Zoning Letter Number: 20-02000046

Re: Waiver Request - Loading Area Dimensional Standards and Screening Standards
790 – 820 SW 12 Ave / Folio numbers: [494202000510](#); [494202030850](#); [494202030840](#)
Site Plan PZ #: 21-12000026

RE: U-Haul Co. of Florida - Property located at 780 NW 12th Avenue, Pompano Beach, Florida (the "Property") – Loading Area Screening and Loading Berth Dimensions

Exhibit "A"

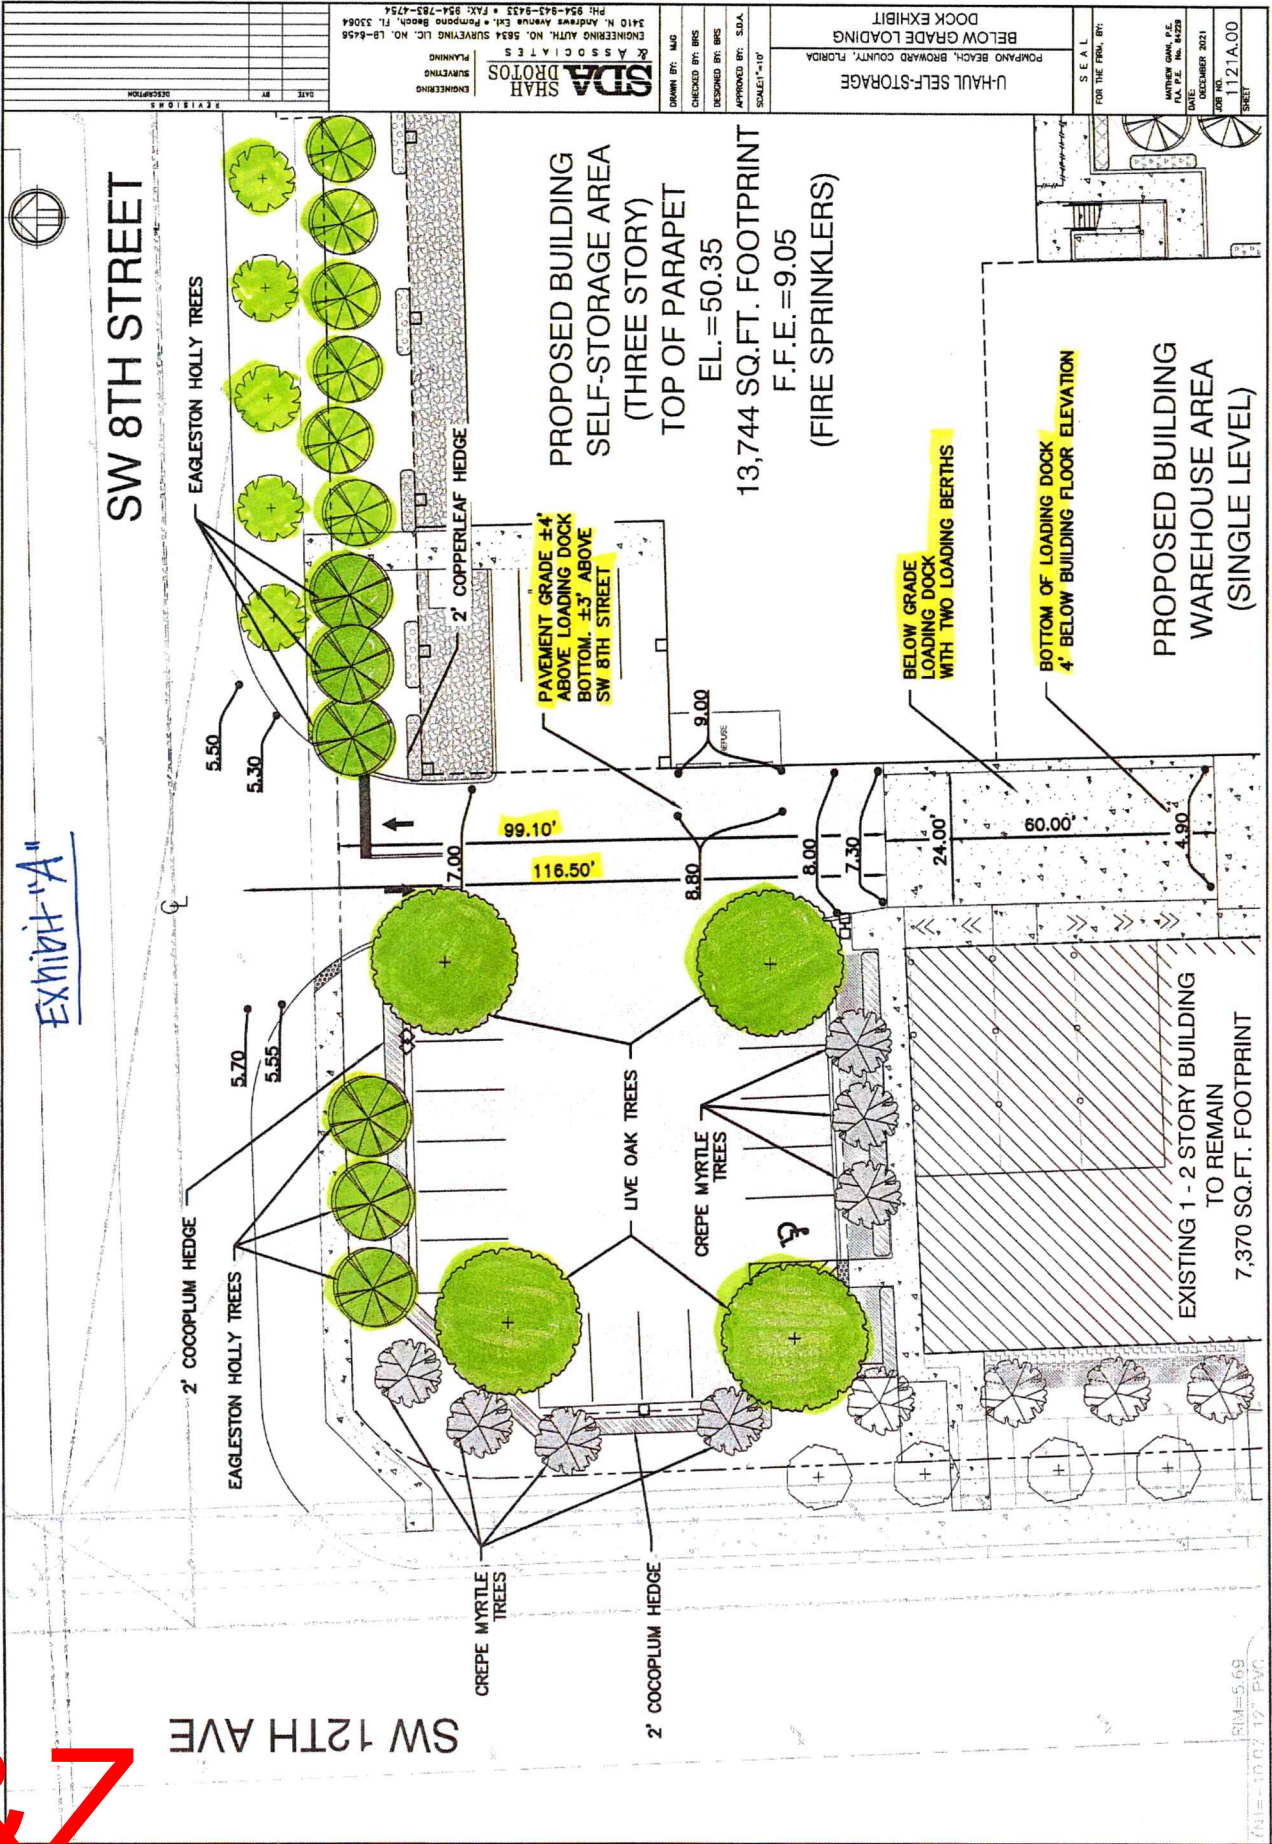
Pursuant to Section 155.5301.B.2, the Applicant's service area with points of vehicular access into or from the Loading Area do not require screening, because the Loading Area has been located and designed to minimize direct views into the Loading Area from the adjacent street and properties, as shown on **Exhibit A** and as set forth below:

- a. The location of the existing office building, proposed self-storage building, street trees and parking lot landscaping screen the Loading Area from various angles along SW 8th Street, therefore minimizing views of the Loading Area from the adjacent street, which is generously setback almost 100 feet from the Loading Area. The buildings on either side of the Loading Area as well as the large Live Oak trees shown on the landscape plan at the point of access along SW 8th Street, as well as adjacent to the Loading Area, provide a natural screening that minimizes visibility into the Loading Area. Additionally, street trees including large shade and flowering trees have been placed along the SW 8th Street corridor adjacent to the Property, further screening the access point and Loading Area.

Given the justification provided, staff finds the request reasonable to approve a waiver of the above mentioned Code requirement. Conclusively, the request for relief and deviation from Code section §155.5301.B Screening of Off-Street Loading and Service Areas is hereby **GRANTED, subject to the following condition:**

1. If the building fronting on SW 12th Avenue, which serves as the screening of this loading area from the west, is demolished in the future the screening of the loading dock must be addressed.
